**COUNTY OF ALBEMARLE
STAFF REPORT SUMMARY**

PROJECT: ZMA201500002 Franklin Street Steep Slopes

PROPOSAL: Request to change the zoning designation of 37,918 square feet from preserved slopes to managed slopes which would allow the slopes to be disturbed. *[Note the initial square footage to be rezoned was reduced to 31,894 square feet following further analysis.]*

Figure 1: Areas of Slopes

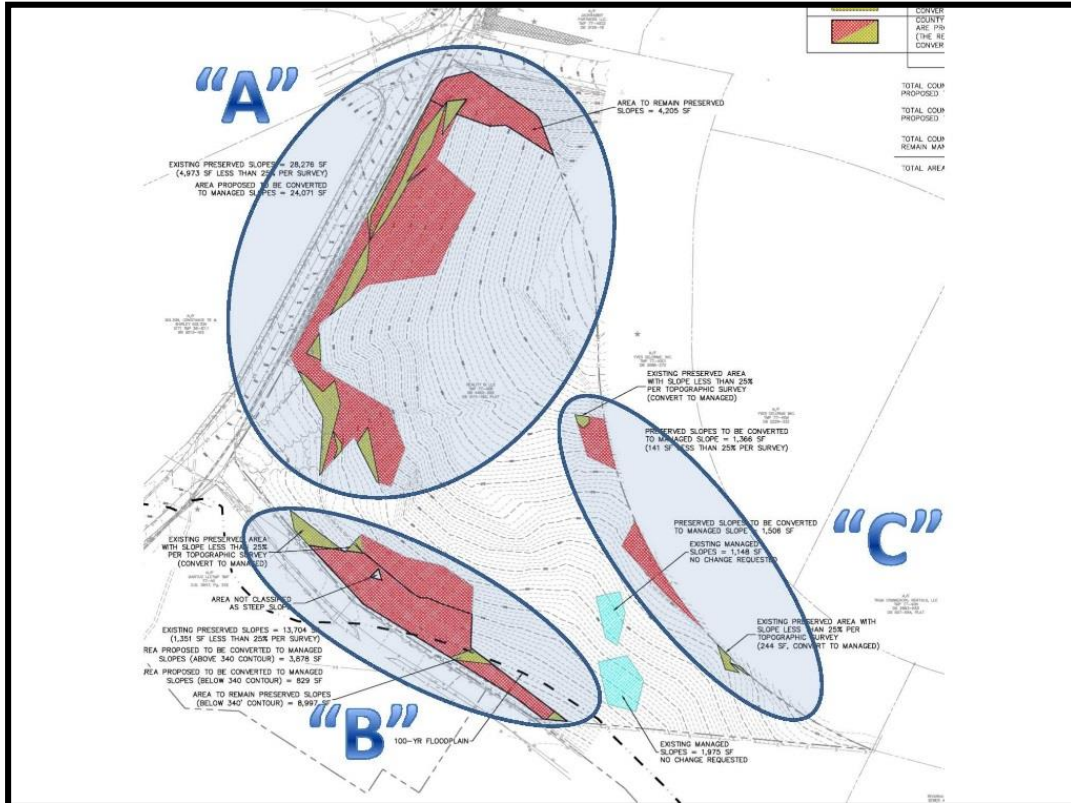
The characteristics of preserved slopes and managed slopes are outlined in Section 30.7.3(a) and (b) respectively and represent the specific criterion used to determine the appropriate designation of steep slopes (see Attachment D). Broadly, staff found the steep slopes on this parcel contained characteristics of both managed and preserved slopes, but will make reference to three distinct areas on the site labeled as “A”, “B” and “C” in the figure below to further explain our analysis.

Figure 2: Area "A"

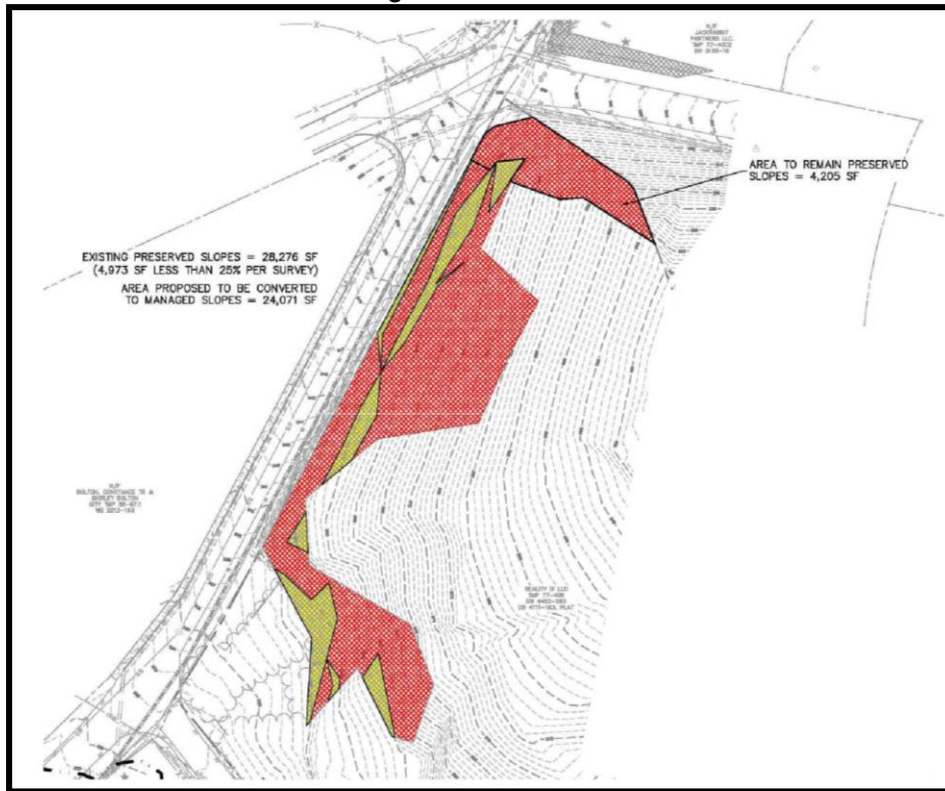
In analyzing this specific area, staff found characteristics of both managed and preserved slopes. In particular, the yellow strips of land that run parallel to Franklin Street significantly fragment the steep slopes. This fragmentation supports the applicant's view that these slopes are manufactured. Other reviewers also agreed that the extent to which this area became steep slopes (greater than 25% grade) was likely the result of the construction of Franklin Street. That said, even though the largest contiguous area of preserved slopes in area "A" is less than 10,000 square feet (which is characteristic of managed slopes), the sum of this grouping overall is greater than 10,000 square feet (which is characteristic of preserved slopes).

Staff also found the context of slopes for area "A" to be an important factor to consider. The adjacent properties to the west of the subject parcel (Parcel 40C1 and Parcel 40M) show a large area of managed slopes across the front of their property (shown in yellow in Figure 3). These slopes connect seamlessly to the preserved slopes at the northern end of the subject parcel (shown in green), which might suggest a "hillside system" that would be characteristic of preserved slopes. However, historical maps and engineering review suggest that all of the steep slopes along the southern side of Broadway Street were the result of road construction. Therefore, although the preserved slopes on the subject parcel are a part of a hillside system, that system is mostly manufactured and was significantly disturbed prior to June 1, 2012. This feature is more characteristic of managed slopes.

Staff ultimately recommends that all 28,276 square feet of the preserved slopes in area “A” should be rezoned to managed slopes.

Figure 4: Area “B”

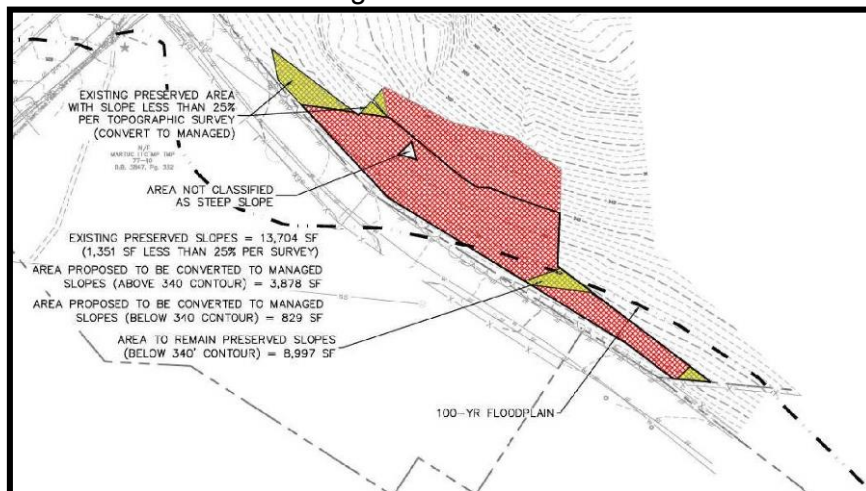
Staff found more characteristics of preserved slopes than managed slopes within this area. The areas determined to be less than 25% grade were mostly found on the periphery of this system and it still yields a contiguous area of more than 10,000 square feet when those areas are subtracted. It is located partially within the floodplain of Moores Creek, so it is associated with an abutting water feature. It is also connected to a much larger system of slopes (see Figure 5 below). Staff believes that even if some portion the steep slopes are the result of the construction of Moores Creek Lane, the size of its contiguous area and proximity to the most impaired watershed in the County warrants its preservation.

Staff ultimately recommends that all of the preserved slopes in area “B” should remain preserved slopes.

Figure 6: Area “C”

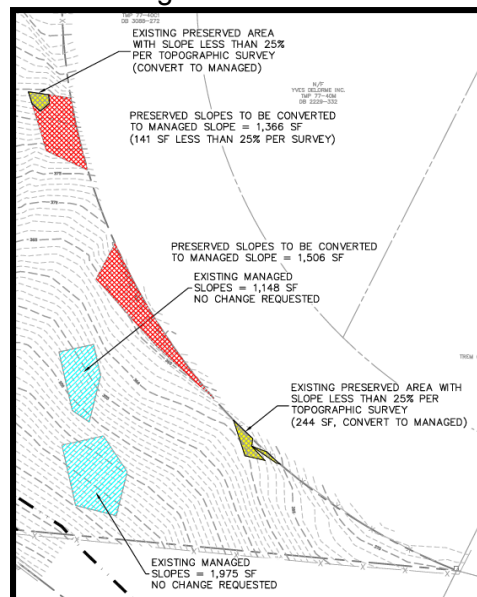
The location of the property line makes these slopes look relatively small and unimportant, but they're actually a part of a much larger system on the County's maps (see Figure 7). Although the field run topography did show some portions of these areas as less than 25% grade, it's difficult to know if that is a more comprehensive characteristic within this system (as observed in area "A") or if it's indicative of only minor modifications along the edges of the system (as observed in area "B"). Without additional information, staff finds it appropriate to maintain these slopes as preserved slopes.

Staff ultimately recommends that all of the preserved slopes in area “C” should remain preserved slopes.
